Conceptual Review Agenda

610 S Grant Ave Fourplex

Re: 610 S Grant Ave - Fourplex

Description of project: This is a request to construct an additional dwelling unit at 610 S Grant Ave (parcel #9714211005). The existing three-unit building will be remodeled with a new 19x38, two-story addition to accommodate an additional unit. As part of this project an existing garage will be removed to allow for the creation of a parking area with 7 new parking spaces. The parcel is located in the Neighborhood Conservation - Medium Density (NCM) zone district. This proposal will be subject to Planning & Zoning Board (Type II) review.

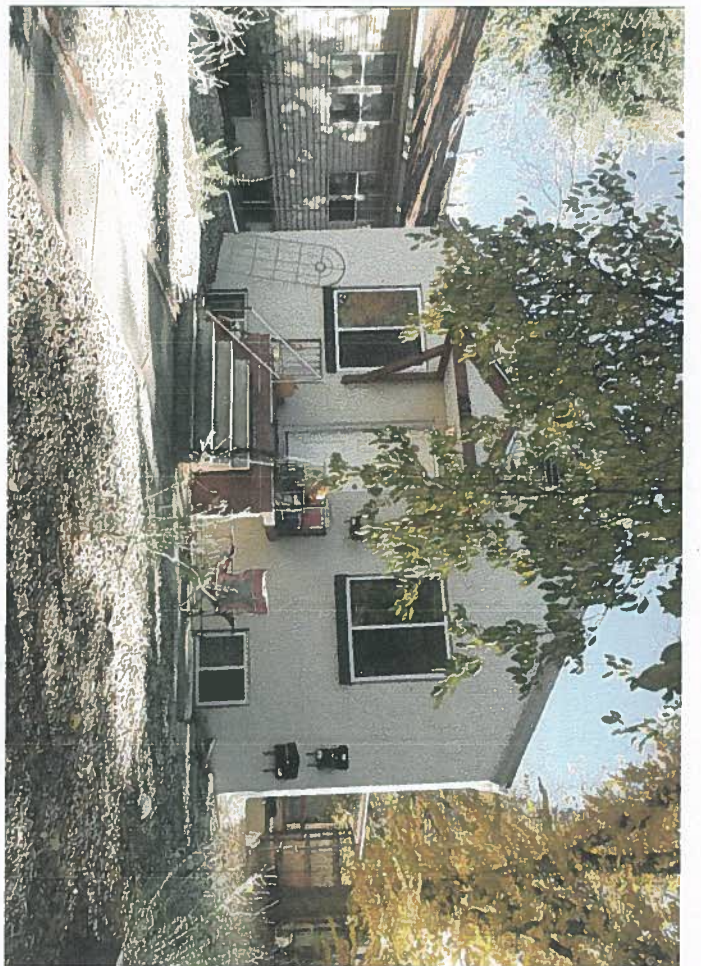
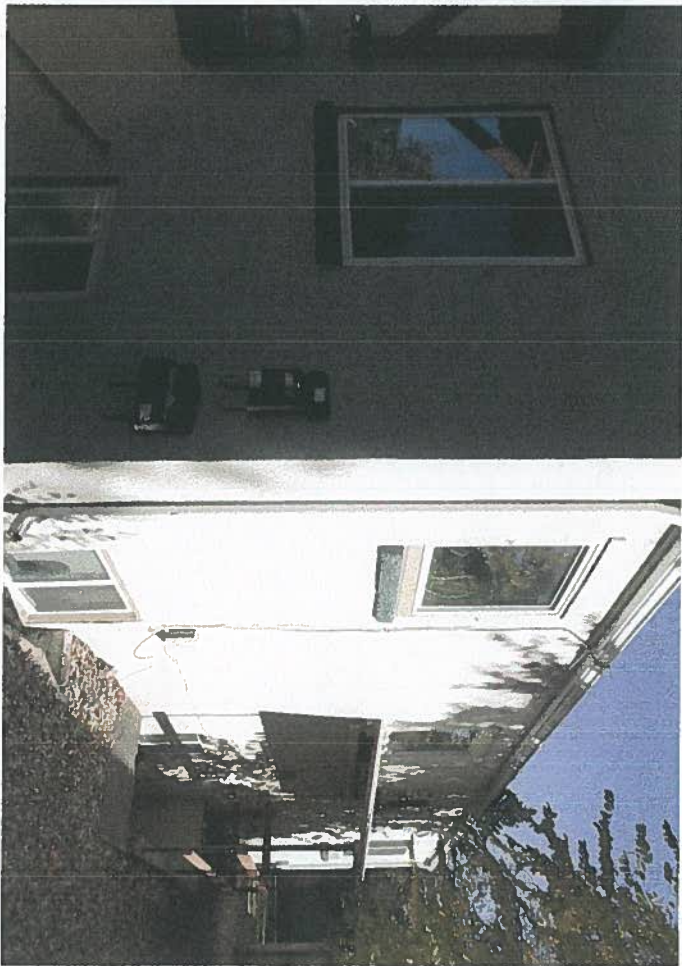
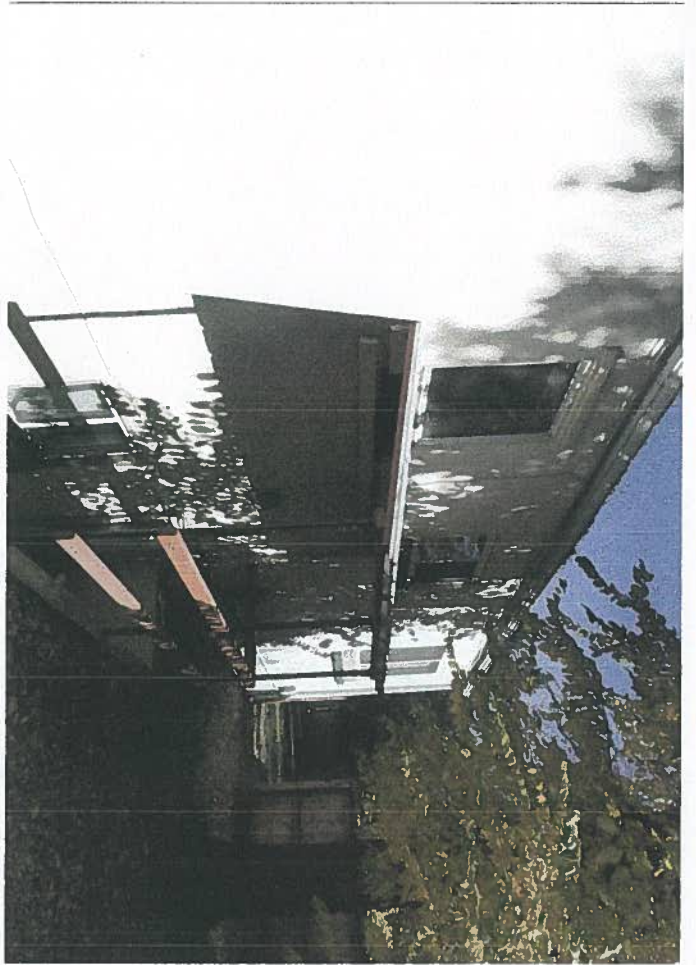
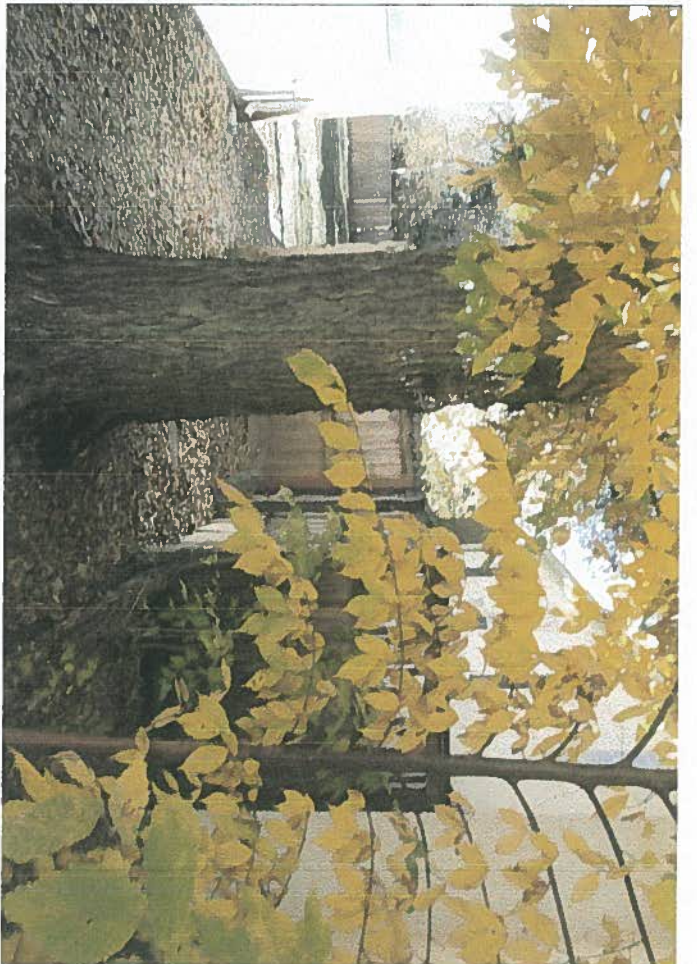
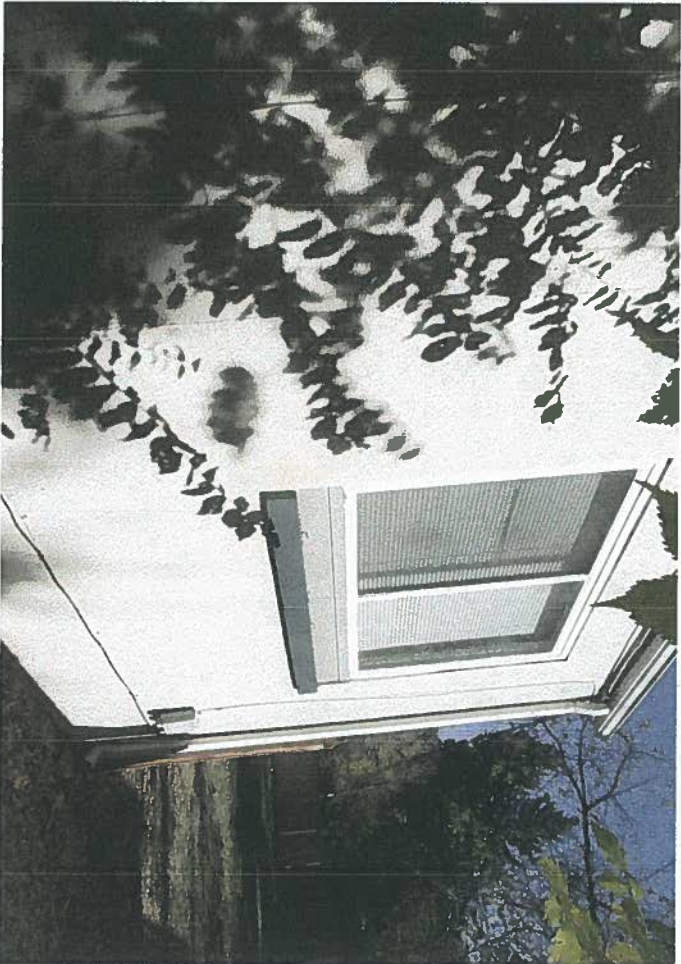
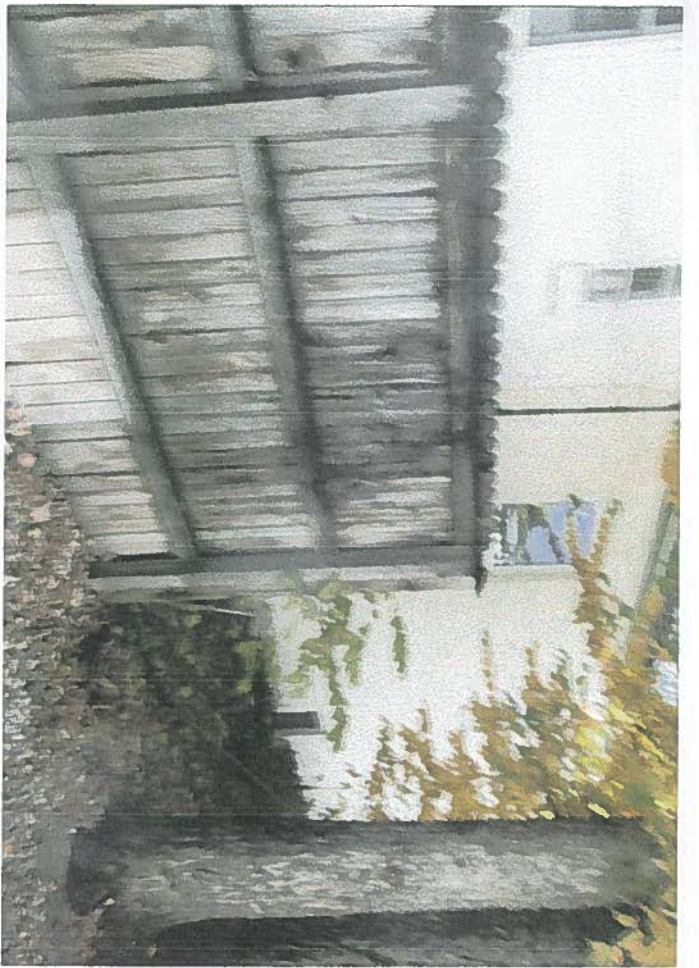
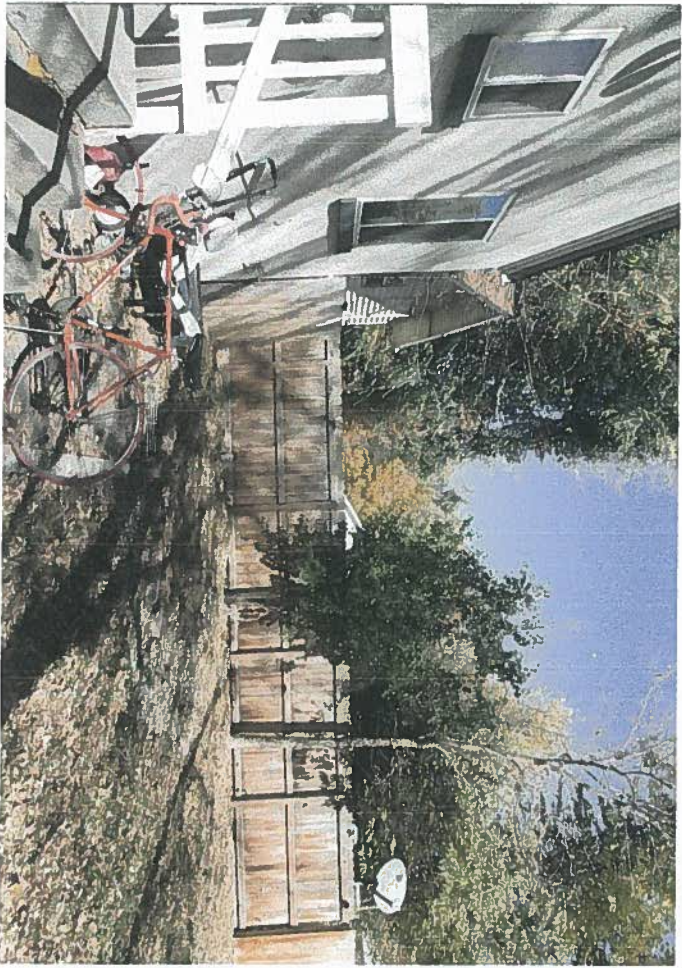
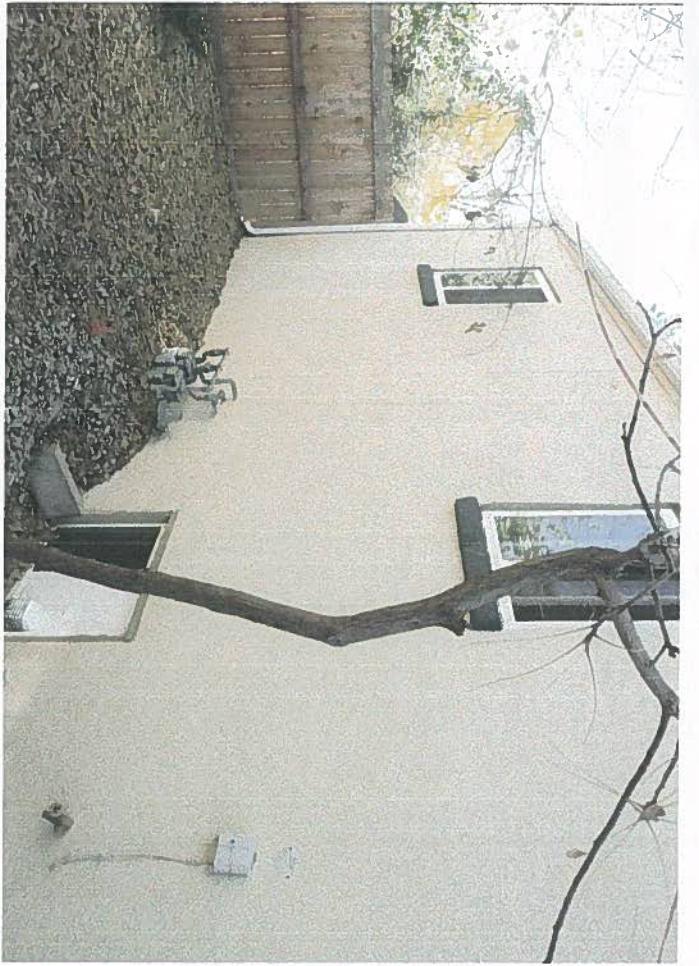
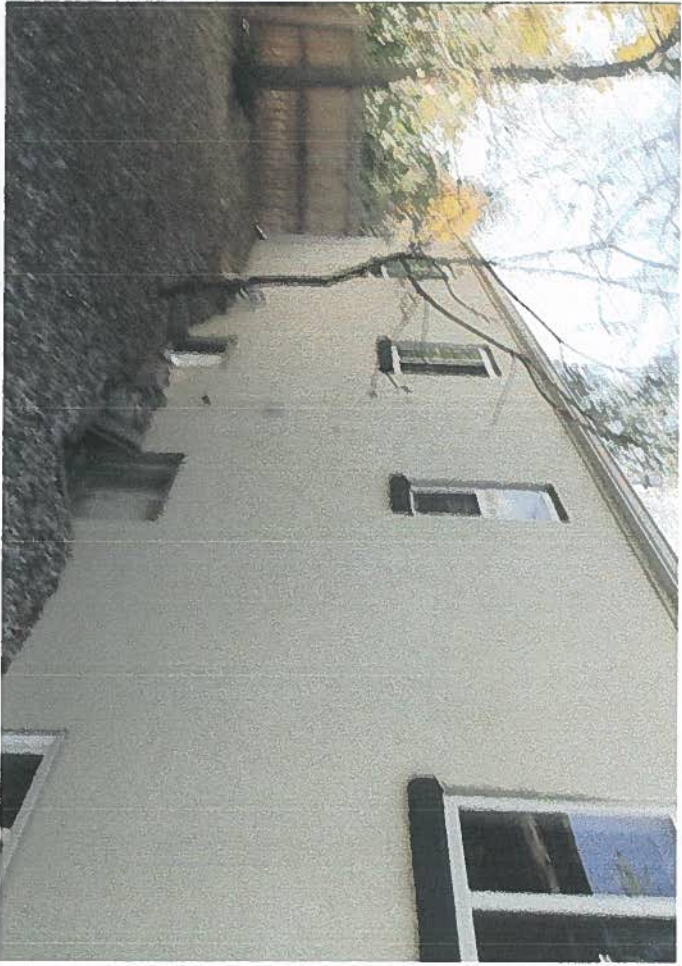
7. The floor area ratio looks to be calculated incorrectly. Based on a lot which is 8,478 SF you could building up to 3161.25 SF. The basement ceiling looks like it is exposed by more than 3 feet so we would count the basement square footage in the floor area. It looks like you are over by 262.75 SF. This would require a modification.

8. With a 5 foot setback along the side lot lines you need to stay under an 18 foot wall height. If you go above 18 feet, you will need a greater setback.

2. The site plan does not show any bike parking. You will need to provide one bicycle parking space per bedroom with at least 60% provided in an enclosed location.

3. While the project narrative and site plan say the addition will be two stories, the floor plan only shows a basement and main level for the addition. Are you counting the basement as a story? If so, will the basement level be more than three feet above grade? Basements that are not three feet above grade do not count towards your floor area ratio calculation.

4. Since the parking area is seven spaces, you will need to provide interior and exterior landscaping that comply with the standards outlined in section 3.2.1(E)(4)-(5). Six percent of the interior parking area shall be landscaped. The perimeter of the parking area shall be screened in such a way to block 75% of the shine of headlights on adjacent uses. The perimeter landscaping standard can be achieved through a mix of fencing, shrubs, and berming.

5. One of the parking spaces shown must be handicap and van accessible.
6. The parking area does not meet the minimum setback of five feet along a property line outlined in Land Use Code section 3.2.2(J). Staff recommends shrinking the drive aisle width to meet this standard. Otherwise, you can seek a modification request to this standard.

10. Based on the lot size provided in the conceptual review (8,695 sq. ft.) the overall FAR limit is 3,174 sq. ft. ($8,695 \times 25\% + 1,000$ sq. ft.). Since the existing structure is 1,980 sq. ft., this leaves 1,193 sq. ft. of additional floor area that can be added. The proposal shows 1,444 sq. ft., which is 251 sq. ft. over the FAR limit. Staff would not support a modification to this standard. If using the square footage of the lot shown by the Larimer County Assessor, then Zoning's FAR calculation apply.

Architectural Site Plan & Details

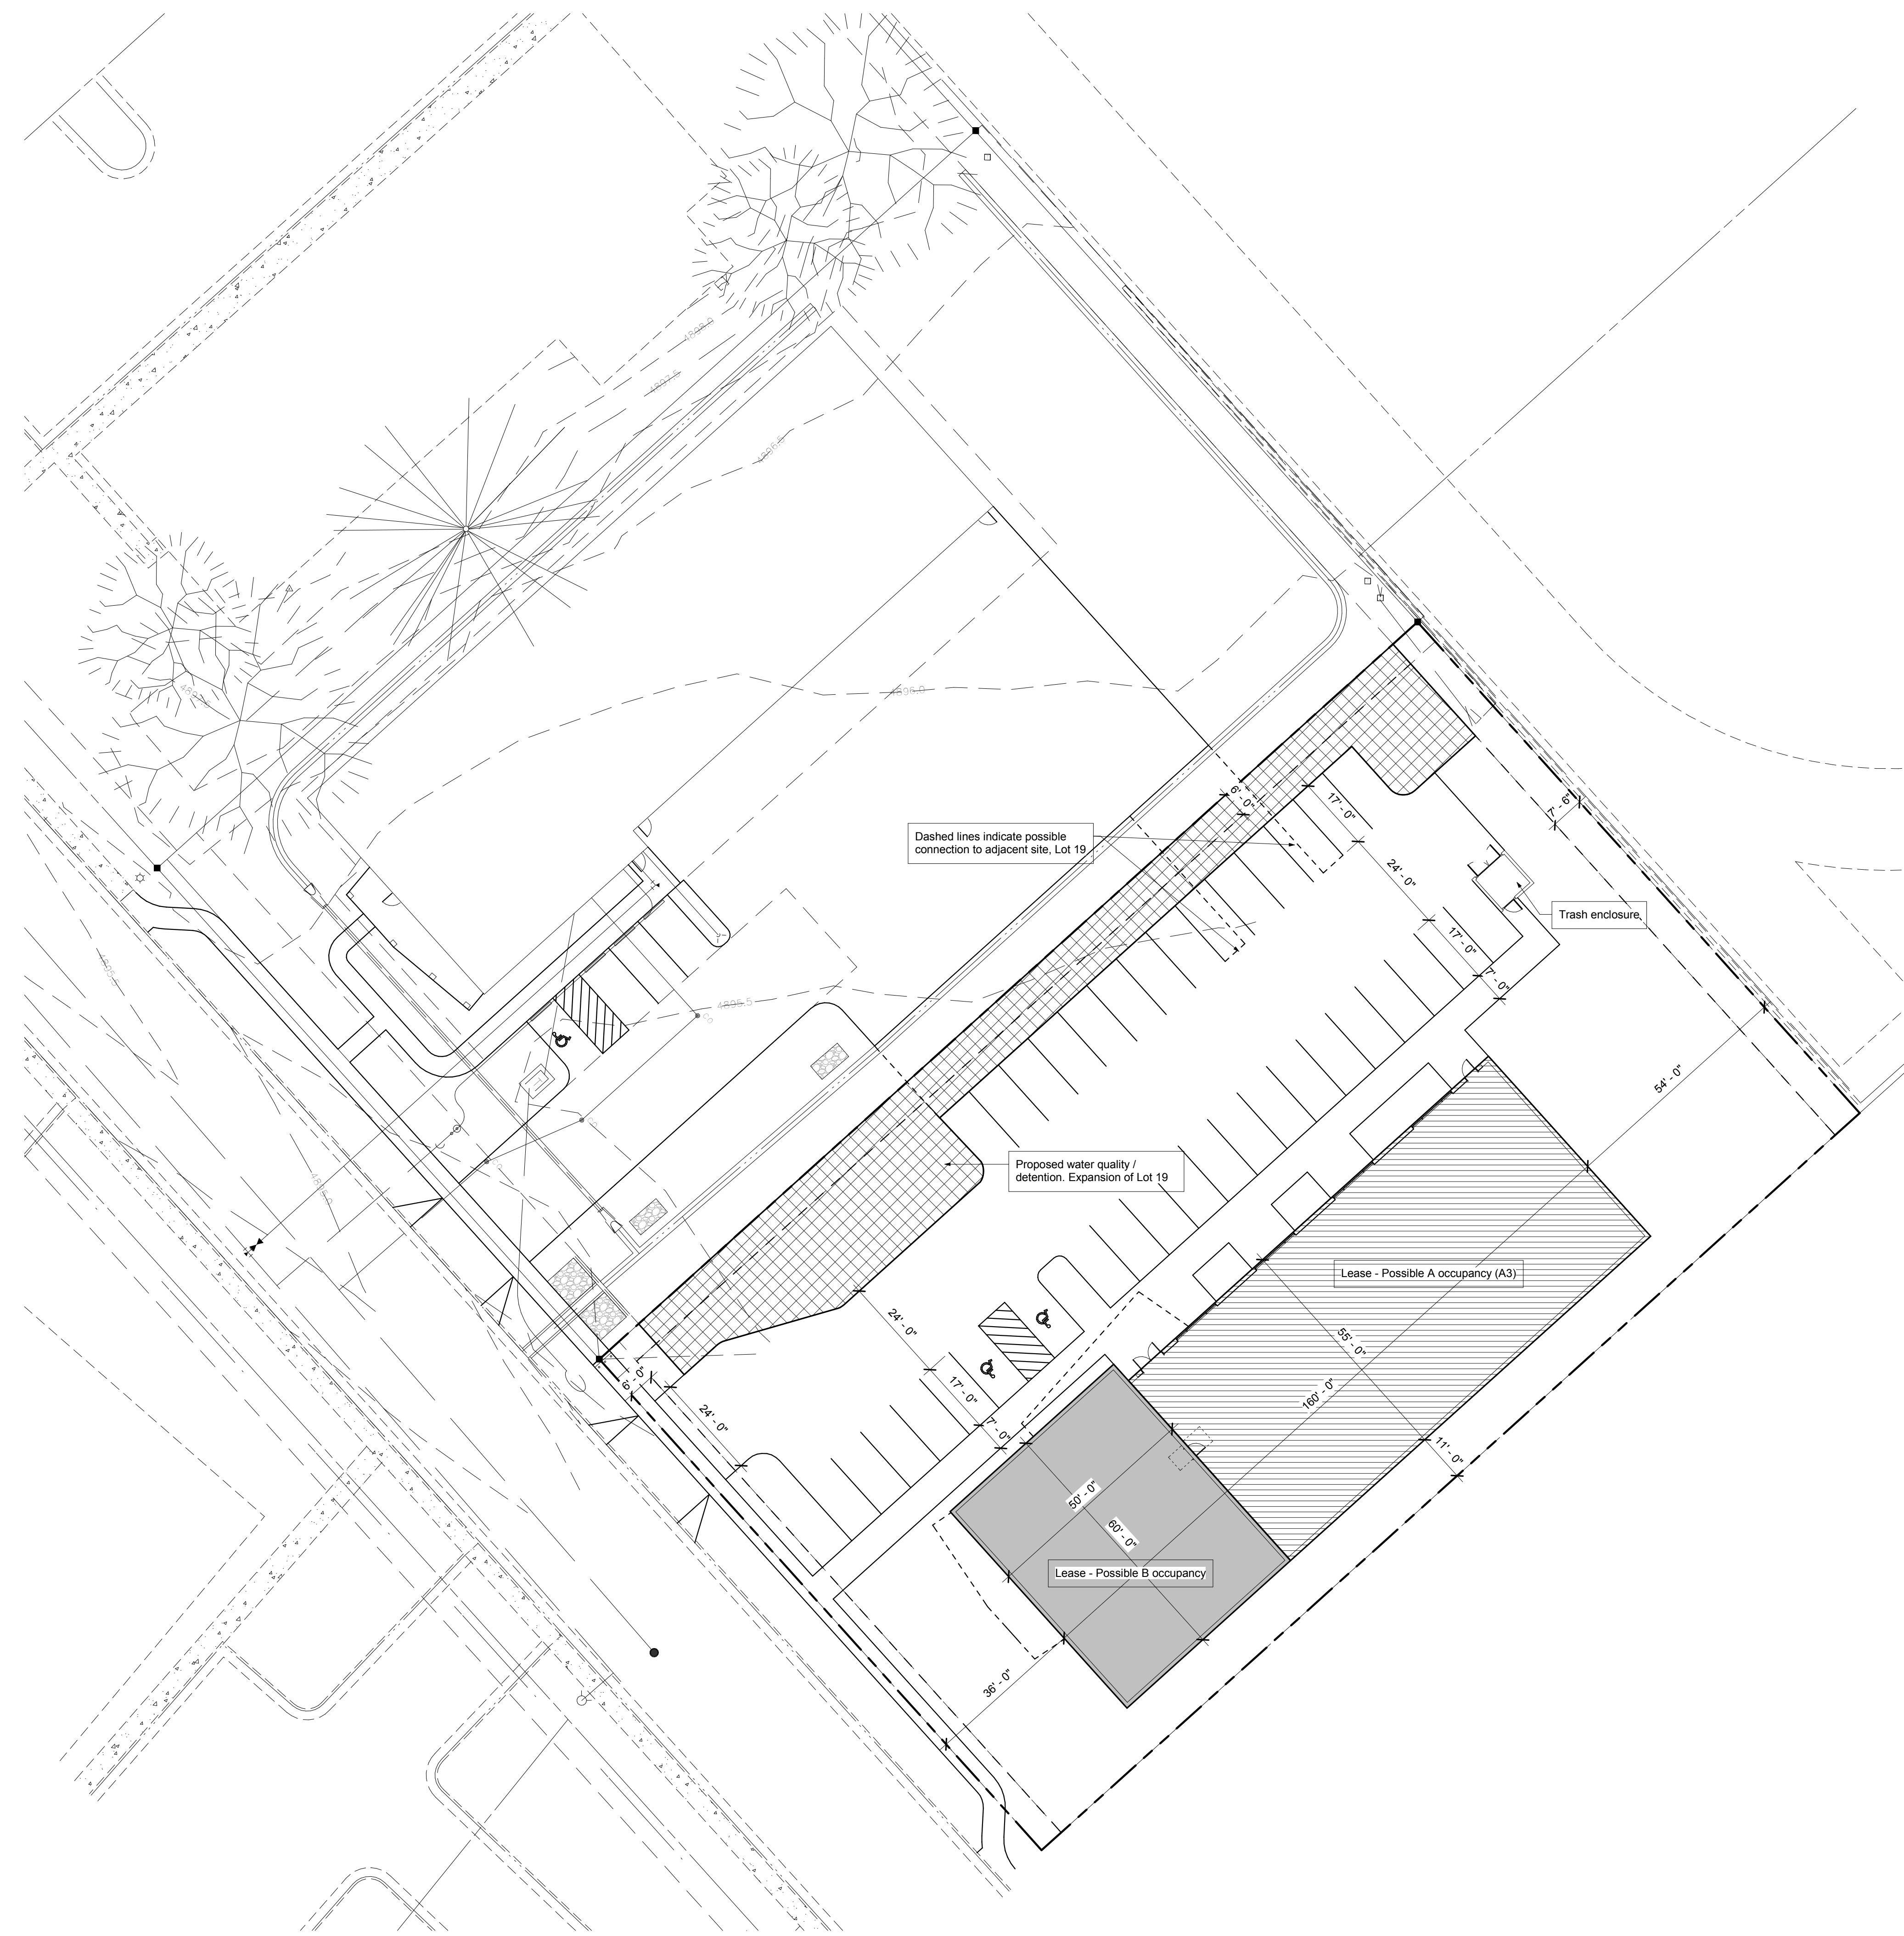
10. LCUASS parking setbacks (Figure 19-6) apply and will need to be followed depending on parking design – the current site plan does not comply with this standard.

1. A minimum 5' landscaped area is required along the rear lot line, and the front parking and drive aisles require a minimum average setback of 10' from the front lot line. If there will be storage, loading, or similar operations required, these operations must be screened from view along the public street.
2. A landscape plan will be required as part of your submittal. Refer to LUC 3.2.1 for landscaping and tree planting requirements to help you prepare your submittal. Some of the most relevant requirements are also included in the following comments:
